SUBJECT: CALVERT CLIFFS NUCLEAR POWER PLANT - NRC EXAMINATION REPORT
05000317/2008301 AND 05000318/2008301

Facility: Calvert Cliffs Nuclear Power Plant, Units 1 and 2

ER 05000317/2008301, 05000318/2008301; June 16 – August 22, 2008; Calvert Cliffs Nuclear Power Plant, Units 1 and 2; Initial Operator Licensing Examination Report.

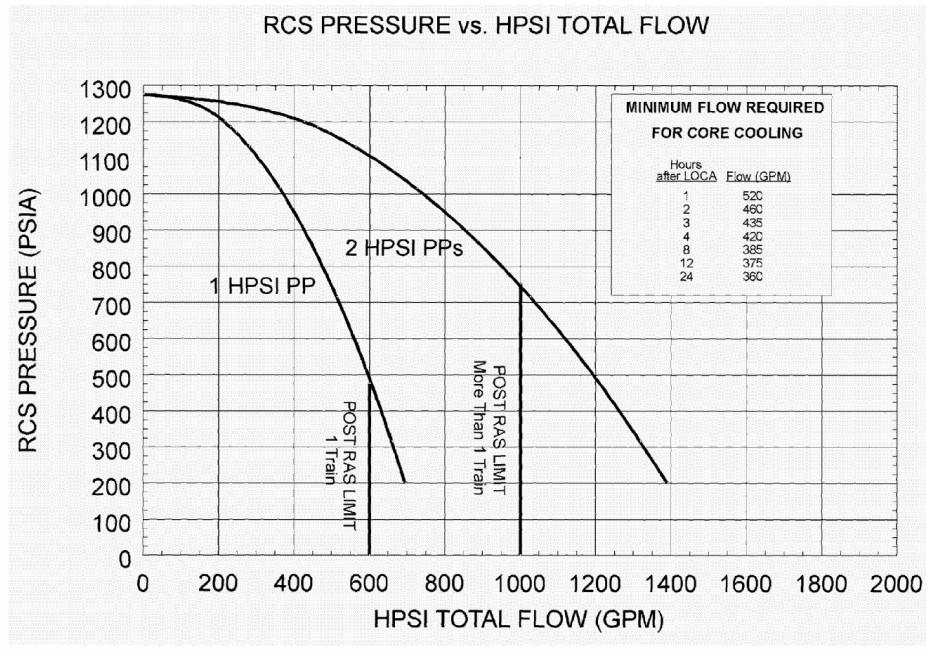
The stem of the question is confusing. Candidates were confused about the meaning of "Which one of the following set of conditions is the **minimum**". EOP-5 basis states that flow out the break is the heat removal process for a large break LOCA. EOP Attachment 10 has a chart that indicates adequate HPSI/LPSI flow for heat removal after a LOCA. Candidates reasoned that core cooling was met by HPSI and LPSI flow and heat removal is adequate if subcooling exists.

The data contained in the question informs the candidate that CET subcooling is 5°F. The intent of the question was to evaluate the candidates' ability to recall the alternate actions for EOP-5 section IV.N.

The question asks the SRO candidates to determine which set of conditions is the **minimum** needed to ensure adequate cooling. Each possible selection informs the candidates that HPSI and LPSI flow were appropriate, which satisfies one component of adequate core cooling. In addition to the HPSI and LPSI flow information, each possible selection gave various T_{hot} values. Six of the seven SRO candidates interpreted the meaning of “minimum conditions” in the question stem other than what was intended.

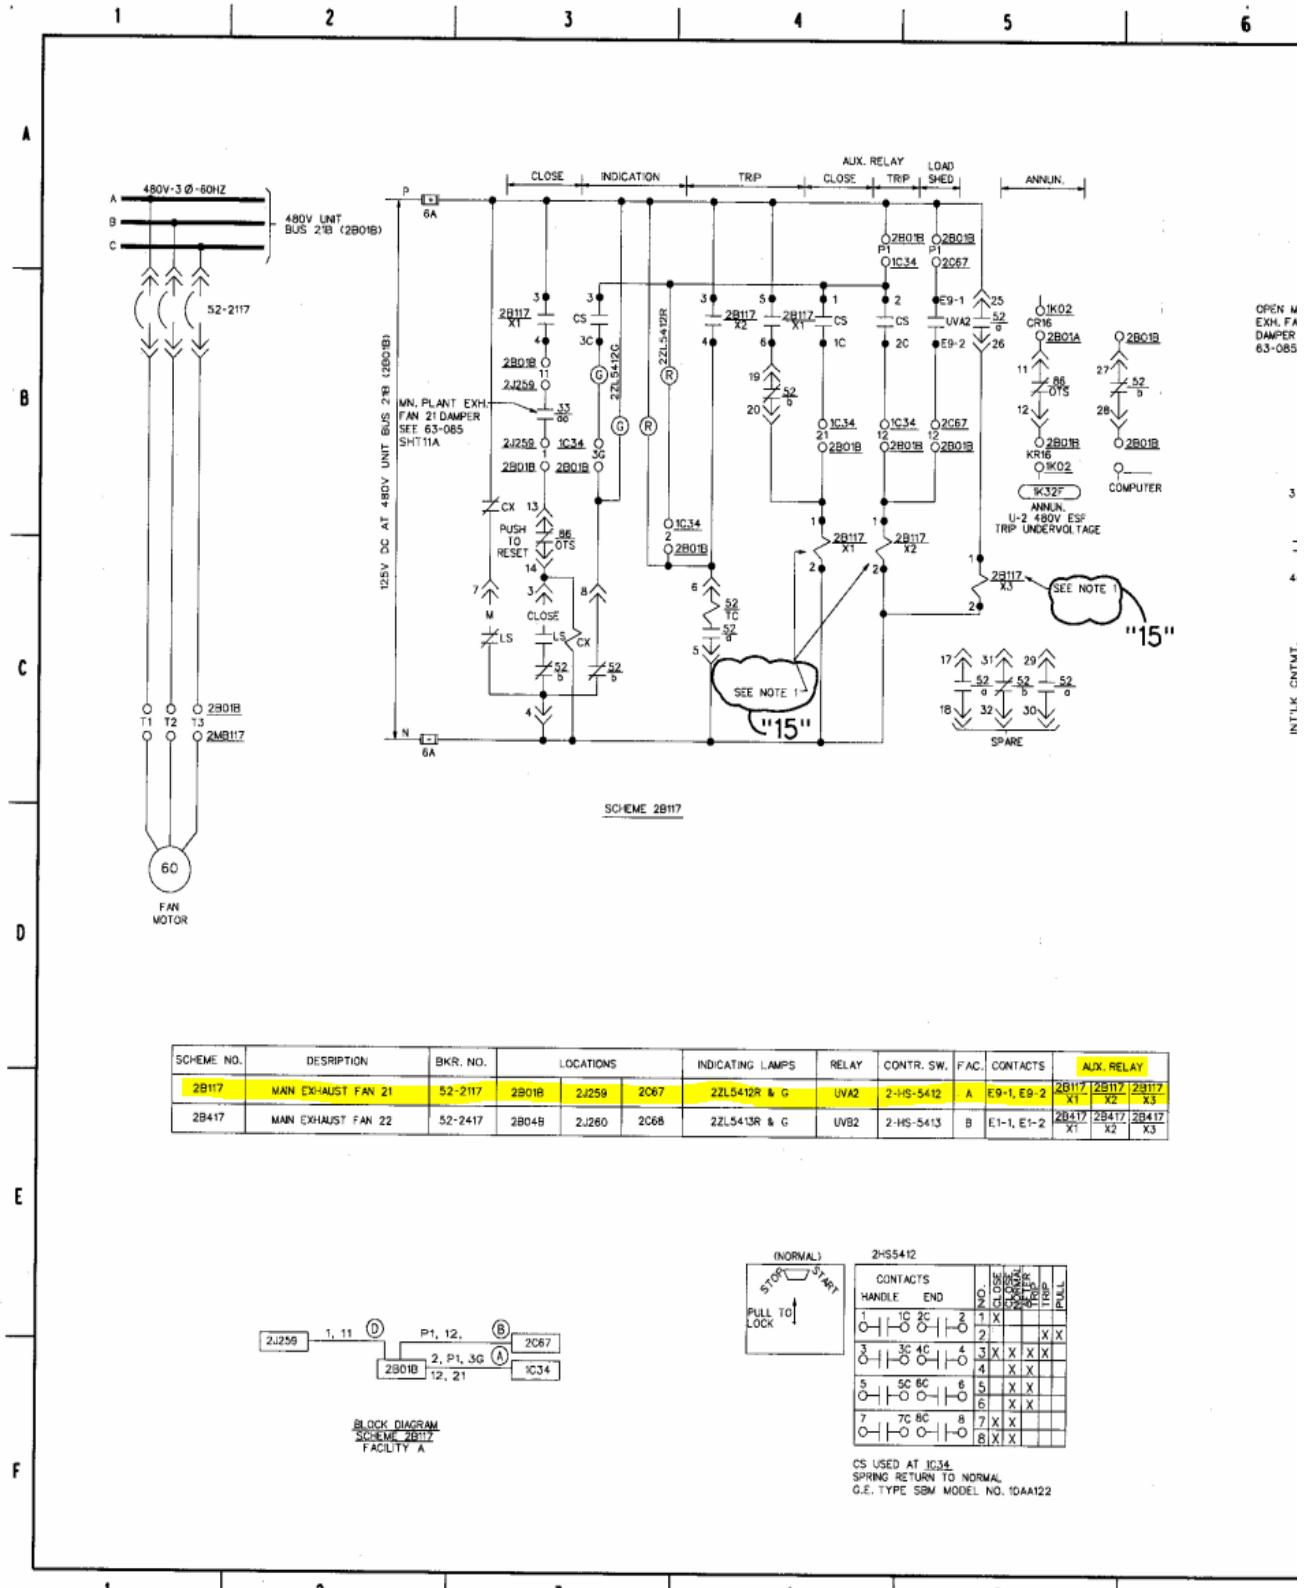
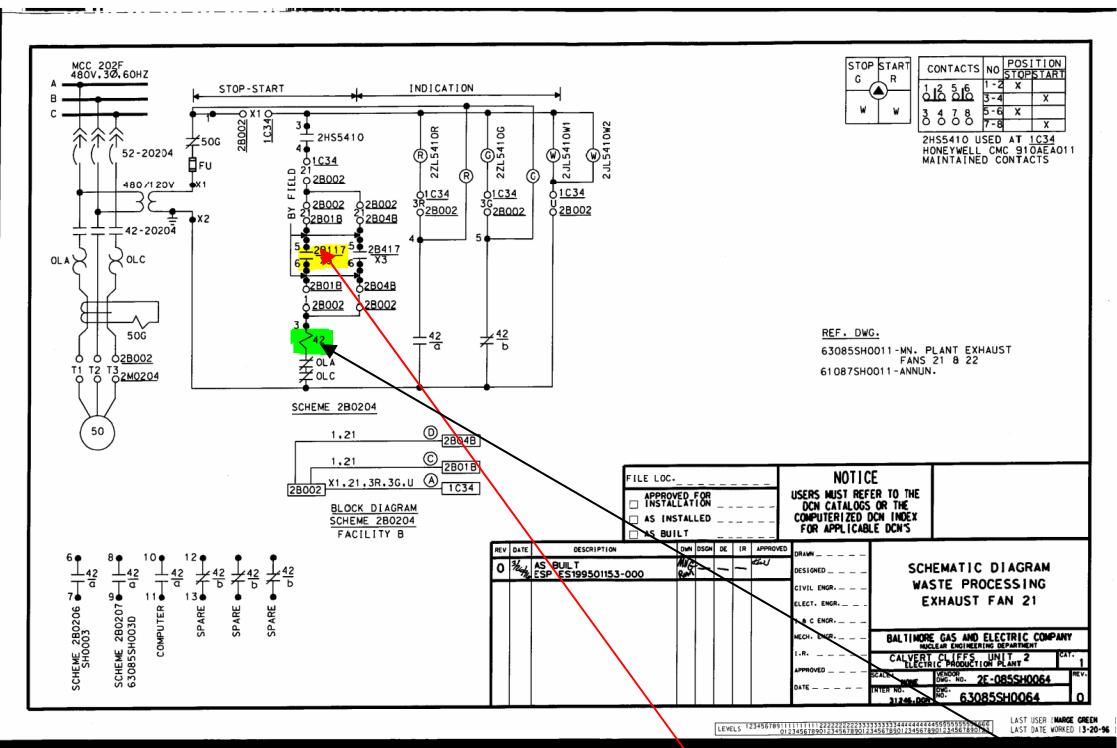
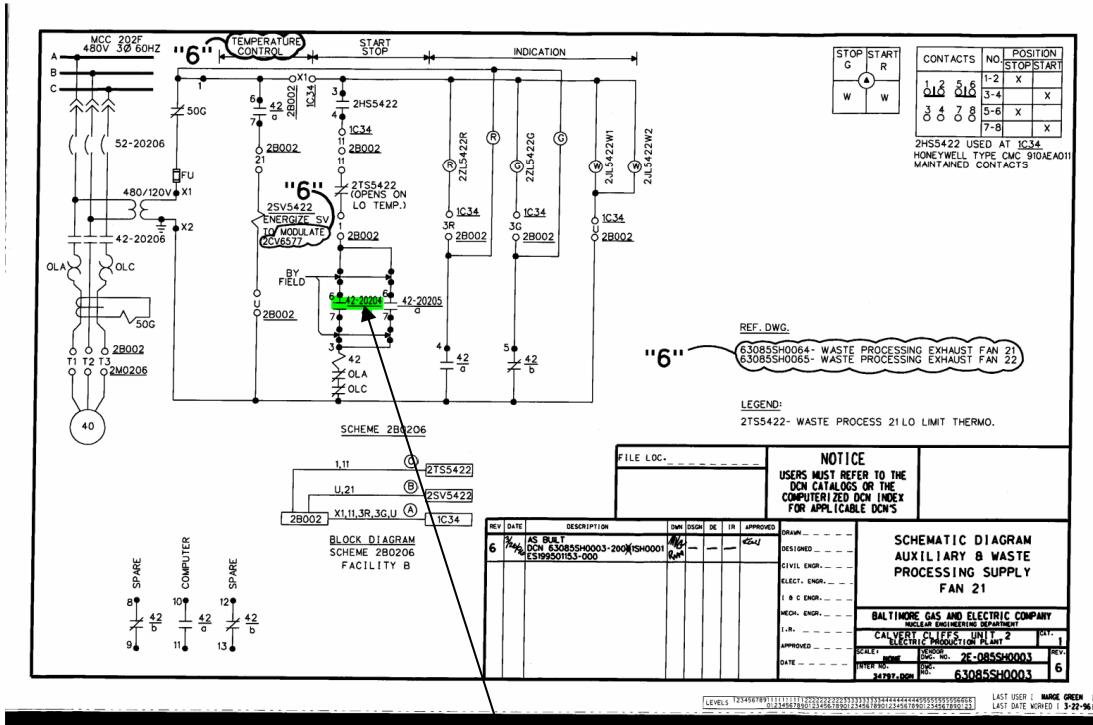
Fuel movement will be suspended in the event of the loss of one of two operating air supply fans, or a change in Auxiliary Building ventilation lineup with a single fan operating. [B-152]

Also The Refuel Machine Procedure OI-25C requires the performance of OI-22D Appendix C Checklist before use of the Refuel machine is permitted. (From OI-25C pg. 10)

The OI-22D Appendix C checklist requires one Aux bldg supply fan running per unit. (From OI-22D Appendix C. pg 2)

Aux Relay 2B117 de-energizing will Open contact 2B117, which will de-energize 42 relay X3 X3

The 42 relay de-energizing will cause the 42-20204 contact to open causing the Auxiliary Building supply fan to trip
